ATTACHMENT C GROUNDWATER/LEAK DETECTION AND LEACHATE MONITORING PLAN

20100-PL-009 Revision 1, Draft

SUMMARY OF PROPOSED TECHNICAL CHANGES TO THE OSDF GWLMP, REVISION 1, JULY 2004

FIGURE 4-3. POST-REMEDIATION SCENARIO

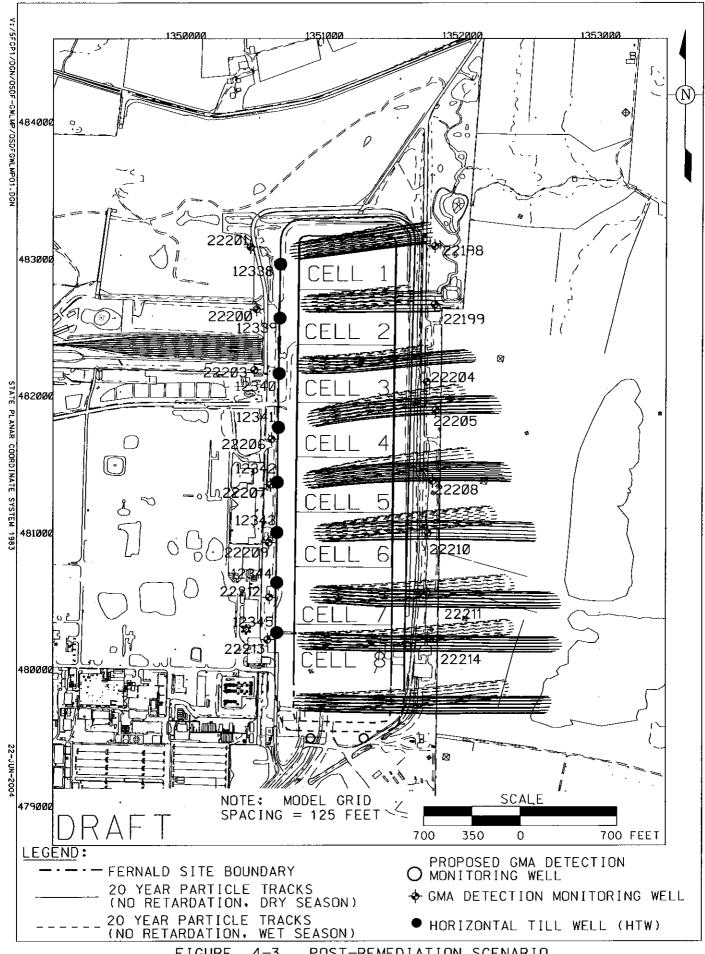
(Communed)	Description of Proposed Change	Delete the following sections:	Section 4.3.4.1 Influence of Aquifer Restoration	Activities Section 4.4.3 Furture Considerations	Section 5.1.2 Monitoring Needs																			Eliminated Figure 4-3 from Revision 0: Horizontal Till Well Cross Section	Instead of including a figure a reference was added in Section 1.0 of Revision 1: (Refer to Plates G-32: Liner System Details and G-44: Horizontal Till Wells and Miscellaneous Details from the January 2004
	Section/Rightre	Deletion of sections from	Kevision o.	Section 4.3.4.1	Section 4.4.5 Section 5.1.2																			Eliminated Figure 4-3 from Revision 0

Section/Figure	Section 4.3.4.1		Section 4.3.4.2 (Figure 4-3)				Appendix B through D	Appendix B

FIGURE 4-5. SWIFT MODELING WITH TECH 99 LOADING - 30 YEARS

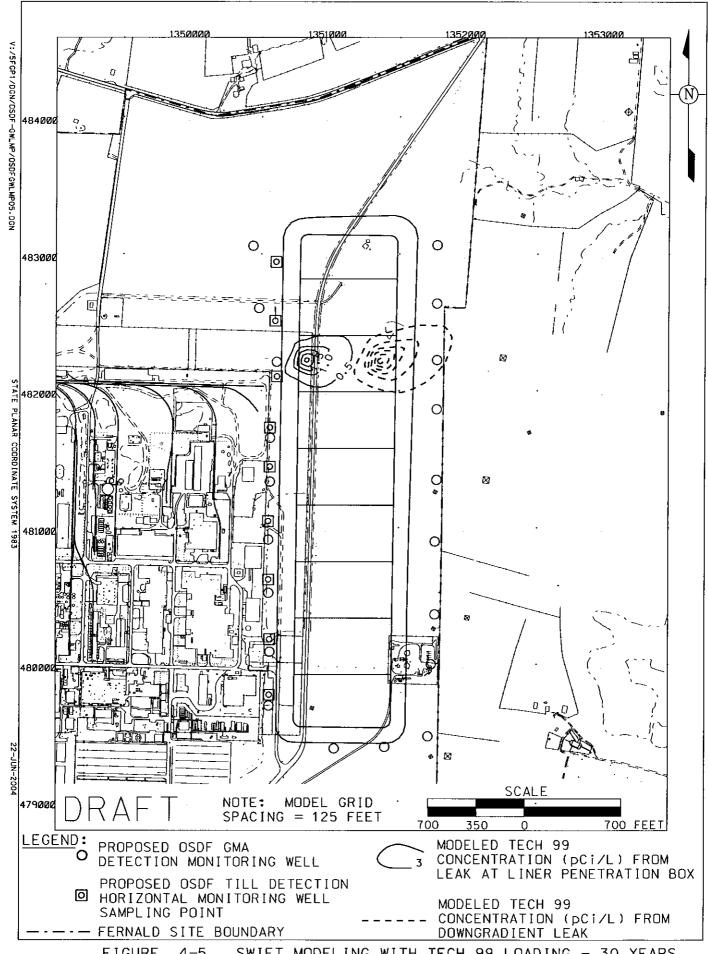
Global (e.g., Sections 2.3 and 2.4) – eliminated Figure 4-5 from Revision 0	The previous revision reflected the Plant 6 groundwater remediation effort. As this is no longer planned, text has been updated to reflect this information.	The previous concentration levels of uranium in the Plant 6 have decreased; therefore, groundwater remediation in this area in no longer planned, as approved by OEPA and EPA.
	Eliminated Figure 4-5 from Revision 0: Plant 6	
Global (e.g., Section 3.0, Appendix A, and Section 5.2)	ARARs and other regulatory requirements were reviewed to determine if there were any necessary updates. Minimal changes were necessary. Examples of updates include: Section 3.1 and Appendix A of Revision 0 referenced DOE Order 5820.2A which has been replaced by DOE Order 435.1. Section 3.2.2 add PCBs to and remove chemical oxygen demand from the annual sampling of leachate (per OAC 3745-27-10 & 19) Section 5.2 of Revision 0 referred to proposed OEPA Policy DDAGW-04-03-221 which has been revised to OAC 3745-27-10(D)(2)	Text has been updated where necessary to reflect current/accurate regulatory references. Primarily, the update has occurred for the following reason: It has been necessary to update the annual list for leachate sampling based on revisions to the OACs, which occurred during 2003. Specifically from review of the OACs (rule 3745-27-19), it has been identified that aroclors-1242, 1254, 1221, 1232, 1248, 1260, and 1016 need to be added to annual LCS sampling, and from OAC Appendix I of rule 3745-27-10 that chemical oxygen demand can be removed. These changes have been implemented with the 2004 annual sampling effort (Documented through the June 7, 2004 conference call between DOE, EPA, and OEPA).
